Access Compliance Report

Public Rights-of-Way

(Curb Ramps)

Intersection ID: 46310		Main Street: BRIDLE_BROOK_WY		Cross Street: BECKET_RIDGE_RD		Location: SE			
ADA ID: D5BC6687CF0F		Ramp Type: PerpDiag		Initial Pass/Fail: Fail		Overall Compliance: No		Severity Score: 10	
Codes/Mitigation Info/Possible Solution					Field Measurements/Component Compliance

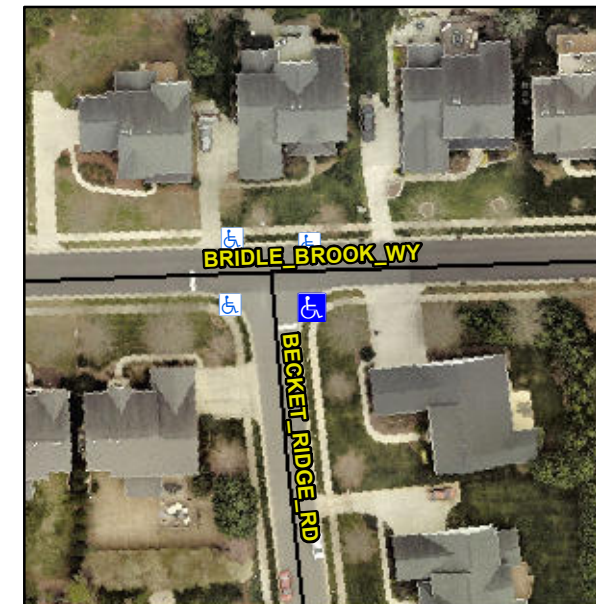
Not Found, R304.5.1, R304.5.3

Compliance	Description	Data	Compliance	Description	Data
N/A	Ramp Length (in)	48.0	Yes	Ramp Slope (%)	6.0
No	Ramp Width (in)	43.5	No	Ramp XSlope (%)	3.5
N/A	Flare Type LT	N/A	N/A	Flare Type RT	N/A
N/A	Flare Slope LT (%)	N/A	N/A	Flare Slope RT (%)	N/A
N/A	Flare Traversable LT?	N/A	N/A	Flare Traversable RT?	N/A
N/A	Landing Length (in)	N/A	N/A	DWS Provided?	N/A
N/A	Landing Width (in)	N/A	N/A	DWS Contrast?	N/A
N/A	Landing Slope (%)	N/A	N/A	DWS Length (in)	N/A
N/A	Landing X Slope (%)	N/A	N/A	DWS Full Width?	N/A
N/A	Landing Curb? (Y/N)	N/A	N/A	DWS Offset (in)	N/A
N/A	Shared Landing?	N/A			
N/A	Gutter Ponding?	N/A	N/A	Gutter Slope (%)	N/A
N/A	Gutter Lip Ht (in)	N/A	N/A	Gutter X Slope (%)	N/A
N/A	Painted X Walk1?	No	N/A	Painted X Walk2?	No
	X Walk 1 Direction	To N		X Walk 2 Direction	To W
N/A	X Walk 1 Width (in)	N/A	N/A	X Walk 2 Width (in)	N/A
	X Walk 1 Slope (%)	1.5		X Walk 2 Slope (%)	0.3
	X Walk 1 X Slope (%)	1.0		X Walk 2 X Slope (%)	3.3

Remove & Replace Curb Ramp With Two New Directional Ramps or Equivalent.
